Model: Katana		Date:14-Jul-06	No.: RB234015
Subject: Service Manual Revision		Prepared by: S. Ishizu	
From: 2nd Tech Support Sec. Service Support Dept.			
Classification:	<input type="checkbox"/> Troubleshooting <input type="checkbox"/> Mechanical <input type="checkbox"/> Paper path <input type="checkbox"/> Product Safety	<input type="checkbox"/> Part information <input type="checkbox"/> Electrical <input type="checkbox"/> Transmit/receive <input type="checkbox"/> Other (     )	<input type="checkbox"/> Action required <input checked="" type="checkbox"/> Service manual revision <input type="checkbox"/> Retrofit information

**This document summarizes the corrections in the Service Manual for “Katana” (Machine Code: B234/235/236).**

Model: AG-P1 / C1		Date: 14-Jul-10	No.: RG178107
Subject: BK5000 Modified Exit/Driven Rollers for Roller Marks		Prepared by: Hiroaki Matsui	
From: PPBG QA/Service Planning Dept.			
Classification:	<input type="checkbox"/> Troubleshooting <input type="checkbox"/> Mechanical <input type="checkbox"/> Paper path <input type="checkbox"/> Product Safety	<input type="checkbox"/> Part information <input type="checkbox"/> Electrical <input type="checkbox"/> Trans

## 3. Corrected PM table <Page: 2-8>

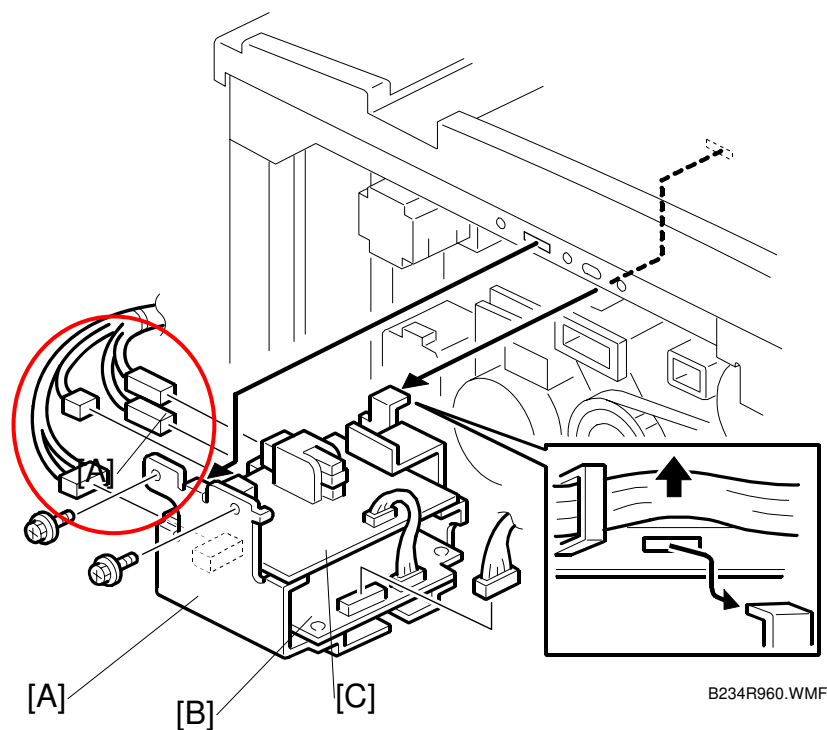
Hot roller gears	C/L			Lubricate (Barrierta 55L or SS552R)
------------------	-----	--	--	-------------------------------------

Hot roller gears	C/L			Lubricate with <b><u>Grease Barrierta – JFE5 5/2 (A2579300)</u></b>
------------------	-----	--	--	---

## 7. Edited title of SP5227 <Page: 5-55>

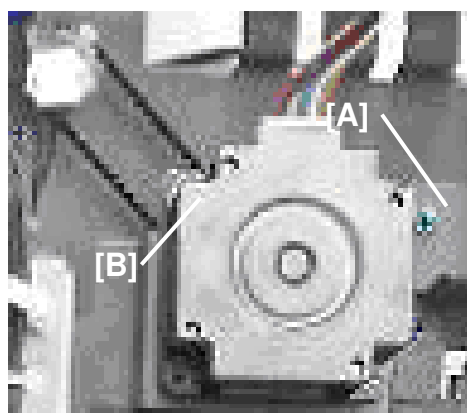
5227	Page Numbering
------	----------------

5227	Page Numbering ( <i><b>Bates Stamp</b></i> )
------	--

## 9. Corrected ELECTRICAL COMPONENT SUMMARY <Page: B830-72>

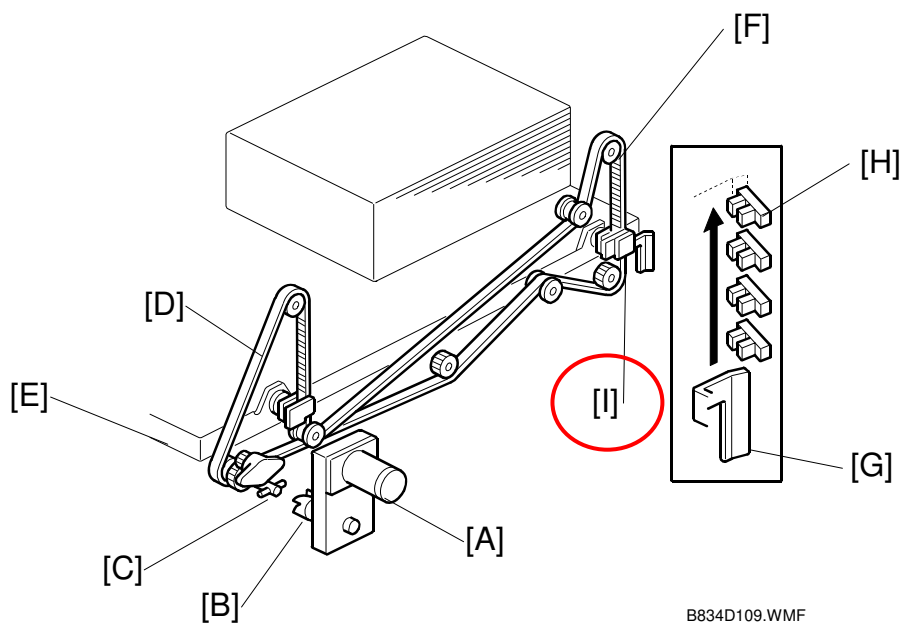
S38	Stapler Rotation Sensor 2	Paired with Stapler Rotation Sensor 1. This sensor pair controls the positioning of the corner stapler for the horizontal, 45° angle, and 75° angle stapling positions.
-----	---------------------------	---

S38	Stapler Rotation Sensor 2	Paired with Stapler Rotation Sensor 1. This sensor pair controls the positioning of the corner stapler for the <b><u>horizontal and 45° angle stapling positions.</u></b>
-----	---------------------------	---

## 11. Corrected the ELECTRICAL COMPONENTS <Page: B836-22>

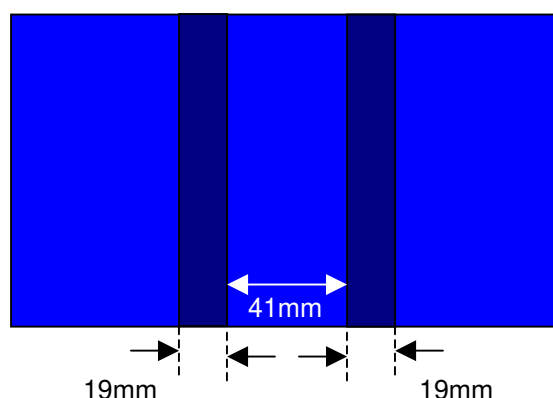
| 1. Horizontal Transport Sensor          | 10. Positioning Roller Motor        |
| 9. Main Board (PCB)                     | 16. Front Door Safety Switch        |

| 1. Horizontal Transport Sensor            | 10. <b><u>Main Board (PCB)</u></b>  |
| 9. <b><u>Positioning Roller Motor</u></b> | 16. Front Door Safety Switch        |

## SOLUTION

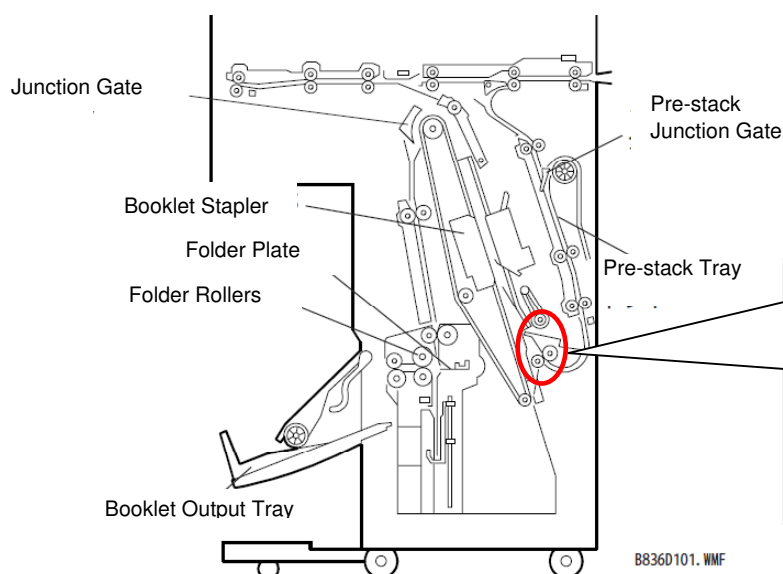
Depending on the print pattern, either of the roller marks shown below could appear when making booklets on the BK5000.

The previous Exit Rollers with large ribs causes excessive pressure against the sheets.

Paper Exit Rollers and Driven Rollers have been modified as described below.

Degree of curl adjustment has been reduced for the Paper Exit Rollers.

1. Size of the ribs surrounding the two Exit Rollers has been reduced.
2. Width between the two Driven Rollers has been widened.

**IMPORTANT**
**Side Effect 1**

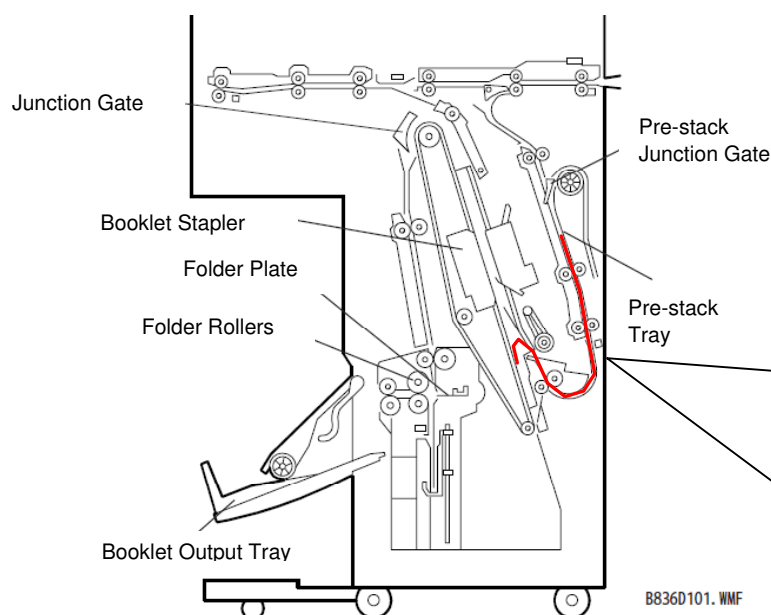
The reduction of curl adjustment at the paper exit could cause the sheet to remain incompletely fed – the trailing edge stays in the Exit Roller area, which could result in incorrect folding positions or jams caused by collision with the succeeding sheet.

As the sheets are fed out with the curls less adjusted, the leading edge is curled immediately after having been fed out from the exit rollers, which could result in jams. The rate of jam occurrence rises especially when feeding "thin and/or curled" sheets.

**Change:** Addition of a screw hole on the Stay and the Stapler Tray

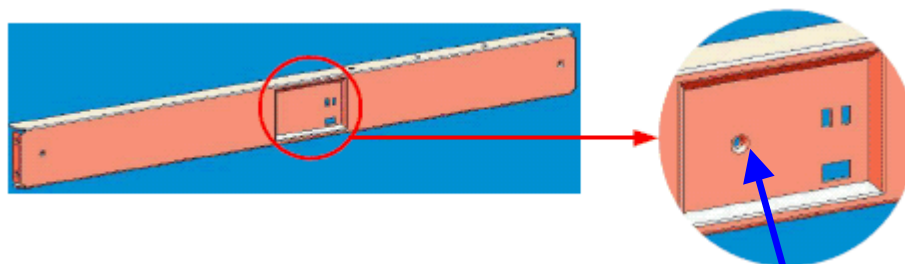
The stapler tray (B7004185) could deform over time and cause the positioning sensor (B7004167) to falsely detect an error.

To prevent the stapler tray from deforming, a new screw hole has been added to fix the tray more firmly, which will ultimately prevent the false detection.

## B7004167 → D3734167 STAY: LOWER: POSITIONING SENSOR

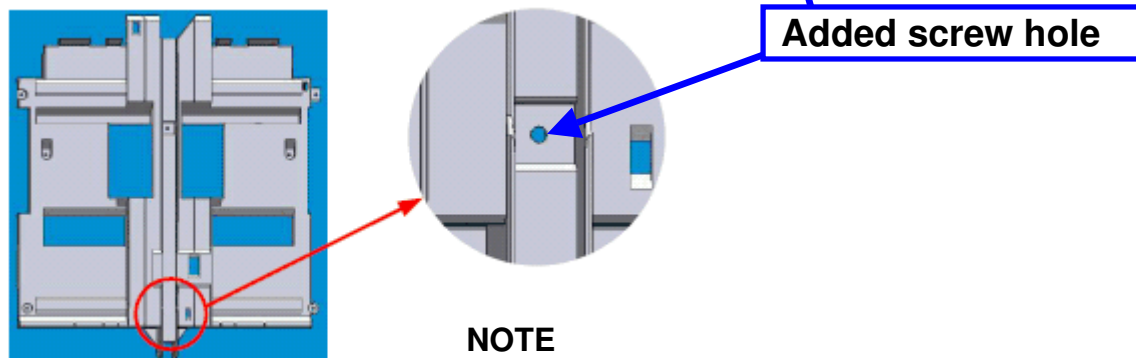
## B7004185 → D3734180 STAPLER TRAY

When fixing the stapler tray, fix the newly added screw hole first using the tapping screw (04543006Q).
